Longfellow Bridge  
Final Design and Added Improvements FAQ  
June 19, 2018

- Below is a plan showing the final design of the travel lane, right turn lane and bike lane.

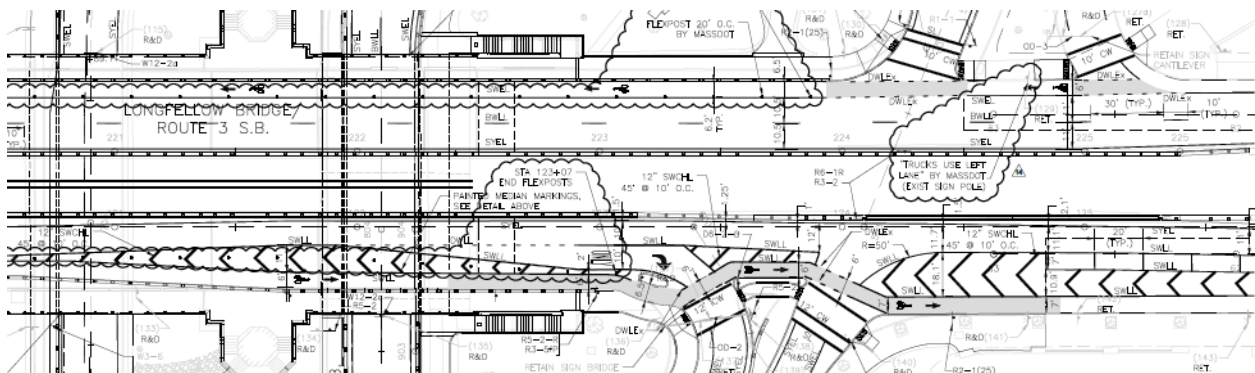
Local advocates have expressed concern related to the bike lane as it transitions off the bridge, passes the Memorial Drive on- and off-ramps and enters into Cambridge. Concerns include:

- “Bicyclist riding downhill may not see the island and will hit the curb and crash.”
- “The island and the zig-zag are very unusual and unexpected.”
- “The design unnecessarily punishes the vulnerable road user.”
- “The design does not make it clear who has the right of way.”
- “The design sends bicyclist directly towards cars in the travel lane continuing towards Kendall Square.”
- “Bicyclists have to focus so much on avoiding the island and maneuvering along the zig zag that they cannot also look for cars going to or from the ramp.”

- The bike lane, just after the Memorial Drive underpass, will receive a high visibility green inlay.
- The island was installed as a traffic calming measure to slow down vehicles as they turn right onto Memorial Drive.

- Bending the bike lane away from the travel lane to provide more yielding distance between right turning vehicles and bicyclists traveling straight is consistent with Chapter 4 of the *MassDOT Separated Bike Lane Planning and Design Guide*, as well as practice in other countries with separated bicycle infrastructure.

- In this design, bicyclists are considered to be making a through movement, and therefore right turning vehicles are expected to yield to bicycles, per MGL Chapter 90, Section 14.

- The resulting zigzag nature of the bicycle facility is to continue providing traffic calming of the bicyclists' speed, while also locating the bike lane, cross walks, and median sidewalk in locations that still allow for ADA compliant slopes in an area with extreme existing grading and right of way limitations.

- An OM1-1, yellow warning sign, has been installed at the island.

- An R10-15 warning sign has been installed at the beginning of the right-turn lane to notify vehicles of the bicycle and pedestrian crossing.
